Agenda Item # 11

SUB-003146-2024 & MOD-003120-2024

Leighton Village Subdivision, Phase III

APPLICATION NUMBER <u>11</u> DATE <u>December 19, 2024</u>	
APPLICANT <u>Leighton Village Subdivision, Phase III</u>	
REQUEST <u>Subdivision, PUD Modification</u>

SITE PLAN

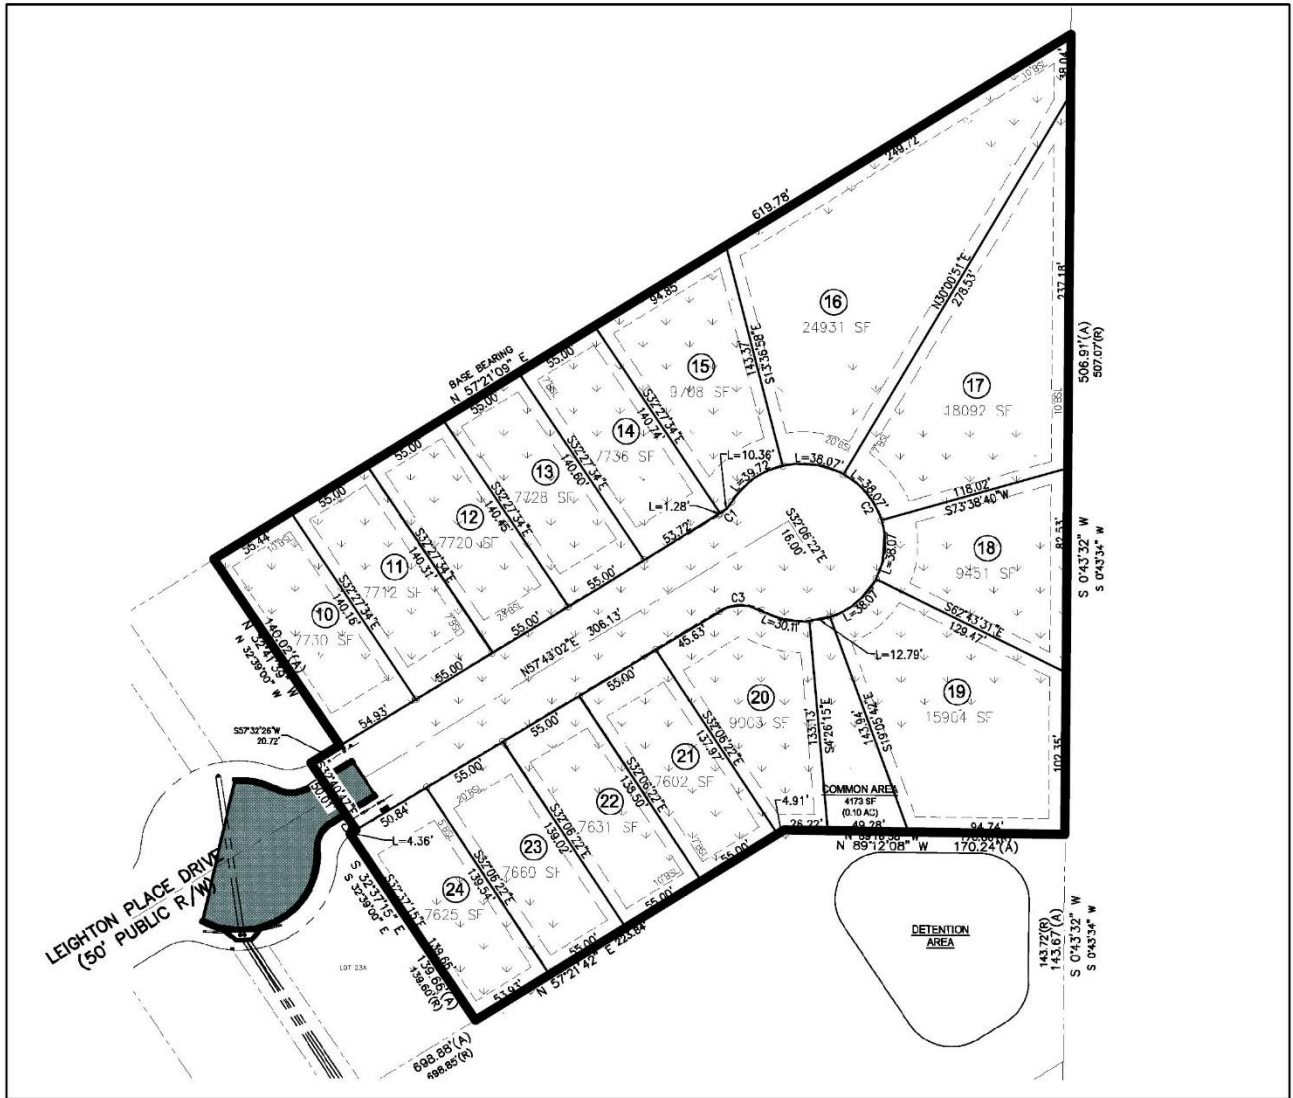
The site plan should be revised to provide a cul-de-sac with a 60-foot radius. The street extension is not named, nor is the right-of-way width provided on the site plan. If approved, the site plan should be revised to label the proposed street extension with its name, right-of-way width, and to label it as a public right-of-way.

The lots are labeled with their sizes in square feet only. If approved, the site plan should be revised to label all lots with their sizes in both square feet and acres, or a table should be furnished on the site plan providing the same information. As the revision of the cul-de-sac to a 120-foot diameter will result in those lots around the cul-

de-sac being slightly reduced in size, the site plan should be revised to provide the revised sizes of those lots in both square feet and acres.

The lots are proposed to have a 20-foot minimum building setback line along the street frontage, as in previous phases of the Leighton Village development. Side yard setbacks are proposed as seven (7) feet (14 feet combined), and ten (10)-foot rear setbacks. The setback data should be retained on the site plan, if approved. The site plan indicates a proposed 50% maximum lot coverage in the Site Data table. If approved the setback data and lot coverage data should be retained in the Site Data table on the site plan.

The site plan should be revised to indicate a City-standard public sidewalk along both sides of the proposed street within the right-of-way, unless a Sidewalk Waiver application is submitted to and approved by the Planning Commission.

The site plan indicates a Common Area within the Southern portion of the proposed subdivision. And the proposed subdivision is adjacent to a large Common Area/Detention Area recorded with the previous Leighton Village Subdivision. Therefore, Note #4 on the site plan should be revised to state that the maintenance of the Common Areas/Detention Areas is the responsibility of the property owners and not the City of Mobile. No easements are indicated on the site plan. If easements are provided within the site, a note should be placed on the site plan stating that no structure may be constructed or placed in any easement without the permission of the easement holder.

1. Revision of the cul-de-sac to provide a 60-foot radius (120-foot diameter);
2. Revision of the site plan to label the proposed street extension with its name and right-of-way width, and labeled as a public right-of-way;
3. Revision of the site plan to label all lots with their sizes in both square feet and acres, or the furnishing of a table on the site plan providing the same information;
4. Revision of the site plan to provide the revised sizes of the lots around the enlarged cul-de-sac in both square feet and acres;
5. Retention of the setback data and site coverage data in the Site Data table;
6. Revision of the site plan to indicate a City-standard public sidewalk along both sides of the proposed street within the right-of-way;

7. Revision of Note #4 to state that the maintenance of the Common Areas/Detention Areas is the responsibility of the property owners and not the City of Mobile;
8. If easements are indicated on the site plan, placement of a note on the site plan stating that no structure may be constructed or placed in any easement without the permission of the easement holder;
9. Submittal to and approval by Planning and Zoning of a revised PUD site plan prior to signing the Final Plat of the associated subdivision;
10. Compliance with all Engineering comments noted in this staff report;
11. Placement of a note on the site plan stating all Traffic Engineering comments noted in this staff report;
12. Compliance with all Urban Forestry comments noted in this staff report; and,
13. Compliance with all Fire Department comments noted in this staff report.
